**Council's Reference: PR.2021.1029**

**Submission State Significant Development - (SSD-10326042).  
Lot 3 DP 1179941, 241 Gorman Drive GOOGONG NSW 2620**

Figure 6: Road Hierarchy

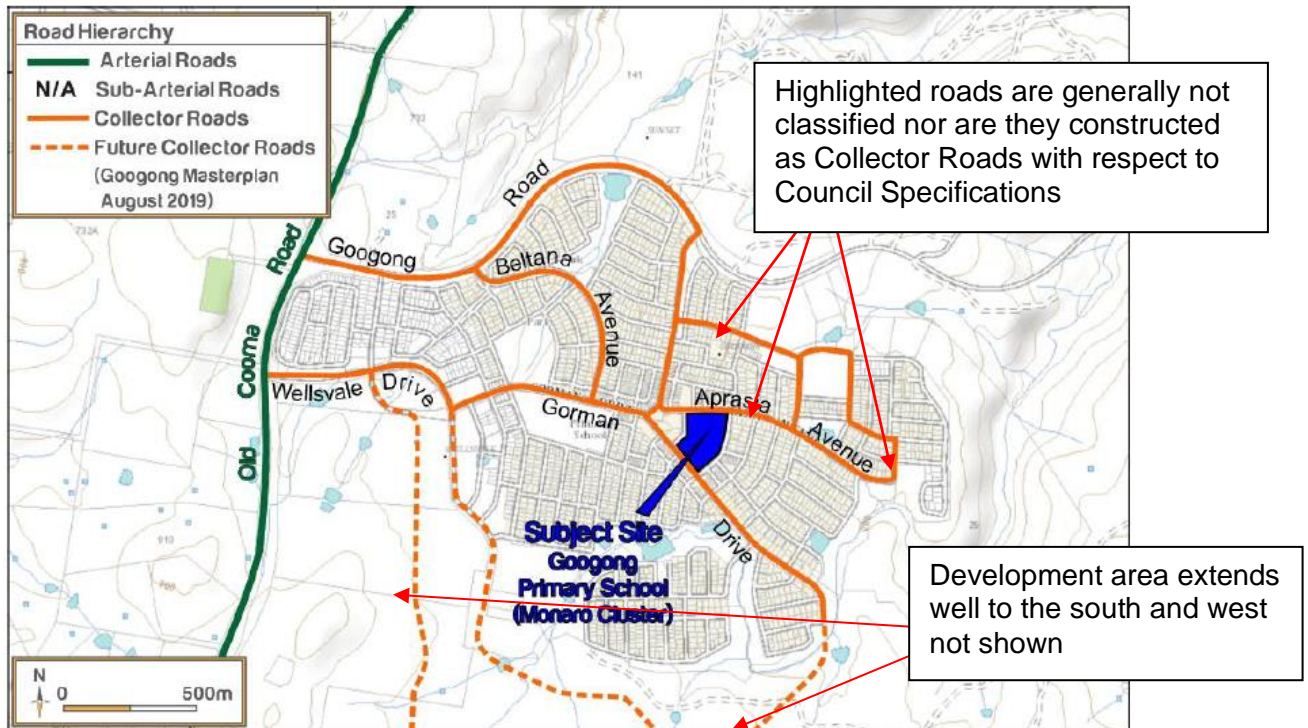
The information extracted from the traffic assessment showing the highlighted roads including Aprasia Avenue are incorrect as they are not constructed as Collector Roads with respect to geometric road design or pavement design. This is particularly evident by the significant road width characteristics of these roads in comparison with other highlighted collector roads. These roads and Aprasia Avenue have been problematic and hazardous roads for Council. The Traffic Impact Assessment in responding to the SEARs requirement 5.1 has not satisfied this aspect of the existing Road Network and Hierarchy.

For this reason Aprasia Avenue is not considered a suitable road for pick up and drop off facilities due to problems associated with the narrow width. No intersection swept path analyses have been provided to support the application for any of the intersections directly surrounding the school site. The assessment does not appear to consider the road widths of Wilkins Way and McPhails Way along with the Caragh/Aprasia and Gorman/Caragh intersections.

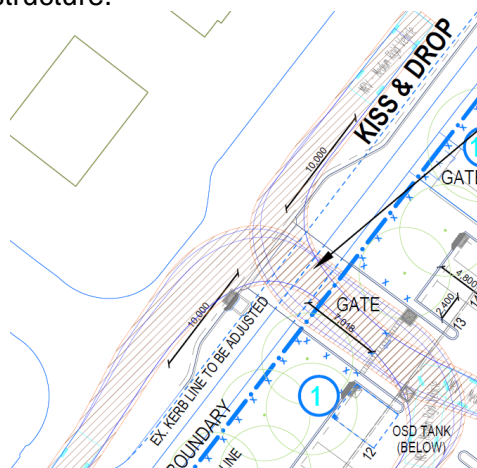
As a secondary preference Council would like to see the drop off/pick up area incorporated into the proposed off-street car park off Aprasia Avenue. Section 9.2.4 of the Traffic Assessment misrepresents Council's secondary preference by analysing an off-street drop off/pick up area separate to the proposed car park.

Council staff do not consider Aprasia Avenue to be conducive to a safe drop off/pick up area and these alternatives present the best outcomes in terms of user safety and traffic generation.

The drop off / pickup area in Aprasia Avenue is to be amended in accordance with Council and TfNSW advice dated 11 November 2020 by construction of indented bays along Wilkins Way.

**Figure 7-15** Construction vehicle haulage routes

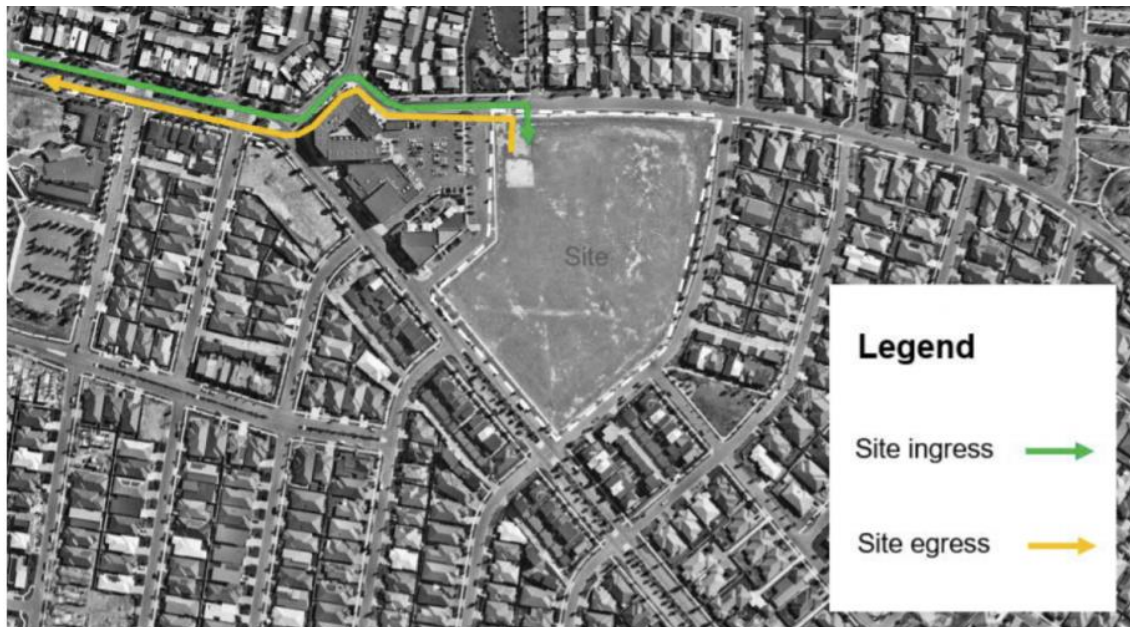
Access to the site via Caragh Avenue and Aprasia Avenue is not considered suitable for heavy vehicles. The site has an existing vehicle crossing on Gorman Drive and heavy vehicles should utilise this entrance. It is also noted that there is no mandate to ensure on-site parking is provided during construction. As on street parking around the site is well utilised, parking must be provided on site to avoid adverse impacts to neighbouring developments.

All vehicles associated with the construction of the development are to park on-site. Access and egress of heavy vehicles is to be via the existing vehicle crossing on Gorman Drive.

**Figure 1: McPhail Way Elevation – Northern End**

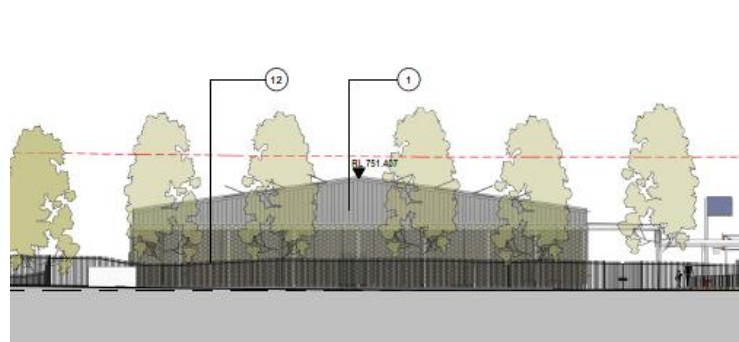
The elevation at the northern end of McPhail Way has a façade that presents a blank wall that could be improved with windows, articulation or change of materials. Landscaping shown on the elevation will soften this portion however, this is not a permanent fix and it is recommended some small changes be made to this building elevation to improve this façade.
